V2500-A1/A5/D5 SERIES PROPULSION SYSTEMS SERVICE BULLETIN

This document transmits the Revision 2 of Service Bulletin V2500-ENG-72-0606.

V2500-ENG-72-0606

ENGINE – HIGH PRESSURE (HP) COMPRESSOR DISCS (STAGES 3–8) – REPLACEMENT OF SILVER
PLATED SHANK NUTS

Repair Details and Dimensions
Figure 1

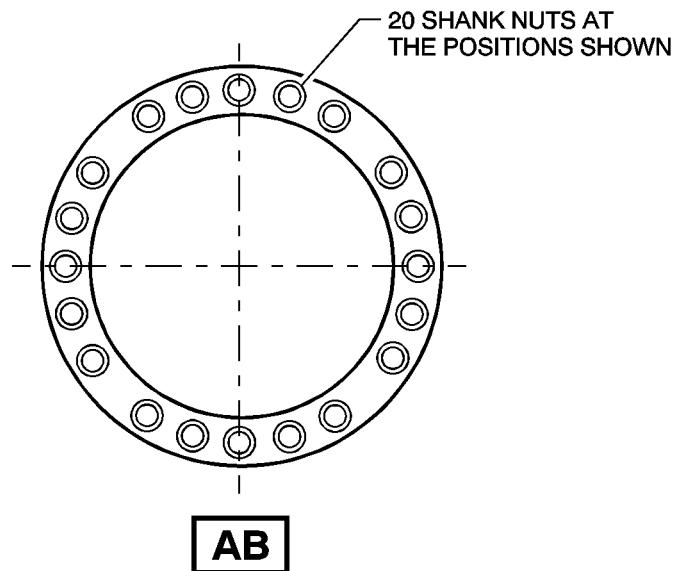
(a) Refer to Figure 1 and Figure 2

(b) Drill the flare until the nut is released

R
R | (d) Remove the sharp edges around the nut location holes and anti frettage plate | Use standard workshop equipment. |

R | (b) Examine the anti-frettage plates | If damaged, reject the plates. |

R
R
R | (b) Install the new nut and anti-frettage plate into the location hole | Use self-locking shank nut - AS63492 with anti-frettage plate - 6A1130.
Make sure the shank nut is installed correctly |

R | (c) Hold the nut and swage the flare | Use IAE 3R18718 (tool bolt) 1 off and IAE 3R18719 (swage bush) 1 off |

Refer to SPP TASK 70-35-11-300-501. Use a drilling machine with a 0.315 in. (8,00 mm) diameter drill.

R
R
R | (a) Do a local penetrant crack test in the area of the repair | Refer to SPP TASK 70-23-05-230-501.
Use CoMat 06-022 fluorescent penetrant with crack test equipment.
Cracks are not permitted |
